Access Compliance Report

Public Rights-of-Way

(Curb Ramps)

Intersection ID: 14509	Main Street: CARONIA_ST	Cross Street: HIRAM_ST	Location: SE
ADA ID: CFF3633D3551	Ramp Type: PerpDiag	Initial Pass/Fail: Fail	Overall Compliance: No
Severity Score: 33.75			
Codes/Mitigation Info/Possible Solution		Field Measurements/Component Compliance

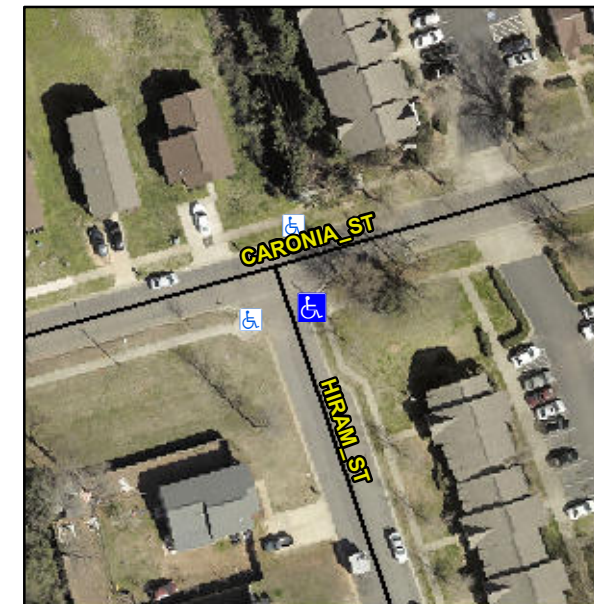
Not Found, R304.5.1, R304.5.3

Compliance	Description	Data	Compliance	Description	Data
N/A	Ramp Length (in)	60.0	Yes	Ramp Slope (%)	5.7
No	Ramp Width (in)	46.5	No	Ramp XSlope (%)	10.3
N/A	Flare Type LT	N/A	N/A	Flare Type RT	N/A
N/A	Flare Slope LT (%)	N/A	N/A	Flare Slope RT (%)	N/A
N/A	Flare Traversable LT?	N/A	N/A	Flare Traversable RT?	N/A
N/A	Landing Length (in)	N/A	N/A	DWS Provided?	N/A
N/A	Landing Width (in)	N/A	N/A	DWS Contrast?	N/A
N/A	Landing Slope (%)	N/A	N/A	DWS Length (in)	N/A
N/A	Landing X Slope (%)	N/A	N/A	DWS Full Width?	N/A
N/A	Landing Curb? (Y/N)	N/A	N/A	DWS Offset (in)	N/A
N/A	Shared Landing?	N/A			
N/A	Gutter Ponding?	N/A	N/A	Gutter Slope (%)	N/A
N/A	Gutter Lip Ht (in)	N/A	N/A	Gutter X Slope (%)	N/A
N/A	Painted X Walk1?	No	N/A	Painted X Walk2?	No
	X Walk 1 Direction	To N		X Walk 2 Direction	To W
N/A	X Walk 1 Width (in)	N/A	N/A	X Walk 2 Width (in)	N/A
	X Walk 1 Slope (%)	5.3		X Walk 2 Slope (%)	1.8
	X Walk 1 X Slope (%)	7.3		X Walk 2 X Slope (%)	3.8

Remove & Replace Curb Ramp With Two New Directional Ramps or Equivalent.
